STATE OF DELAWARE
DEPARTMENT OF TRANSPORTATION
PO BOX 778
DOVER, DELAWARE 19903

February 9, 2016

Contract No. T201011302.01
Federal Aid Project No. NH-2015 (26)
US 13 And Port Penn Road Intersection Improvements
New Castle County

Enclosed is Addendum No. 1 for the referenced contract consisting of the following:

CONTRACT	PERMIT NO.	N784	SG-01: SIGNAL PLAN US 13 @ PORT PENN RD	SHEET NO. 179																		
T210011302	DESIGNED BY: J.D.C. (WR&A)				TOTAL SHEETS 179																	
COUNTY	CHECKED BY: J.M.M. (WR&A)																					
NEW CASTLE

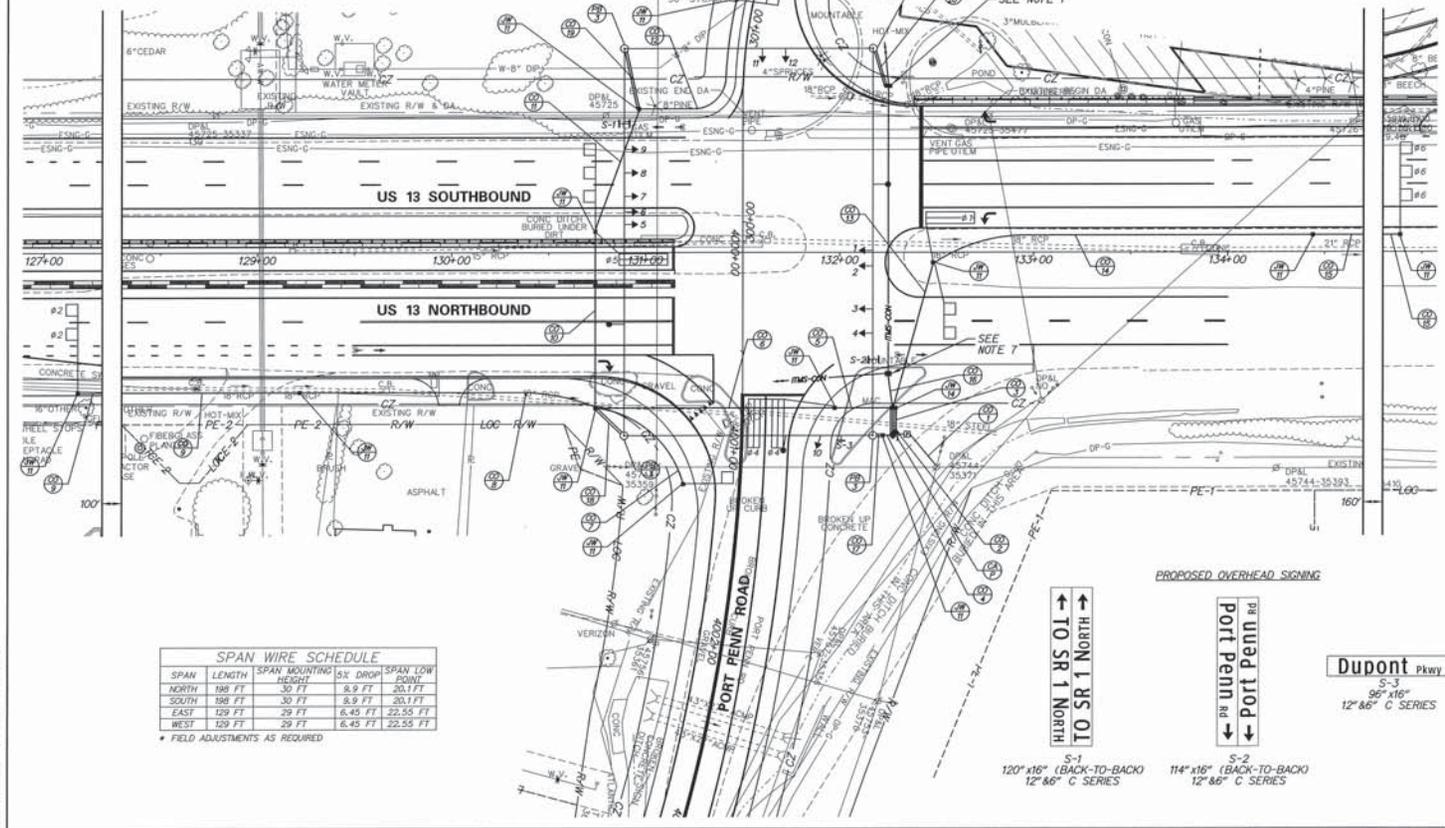
1. One (1) page, Bid Proposal Cover revised, to be substituted for the same page in the Proposal.
2. Two (2) pages, Table of Contents, pages xi and xii, revised, to be substituted for the same pages in the Proposal.
3. One (1) page, Special Provision, 202555 - Subsoil Tillage, page 71A has been added to the Proposal.
4. Nine (9) pages, Special Provision, 737523 - Plantings, pages 153A-153I has been added to the Proposal.
5. One (1) page, Bid Page #16, Item #753515 UOM changed from L.F. to L.S.
6. One (1) page, Plan Sheet 179 of 179, revised, to be substituted for the same page in the Proposal, signature added.
7. Expedite File, Addendum No. 1.
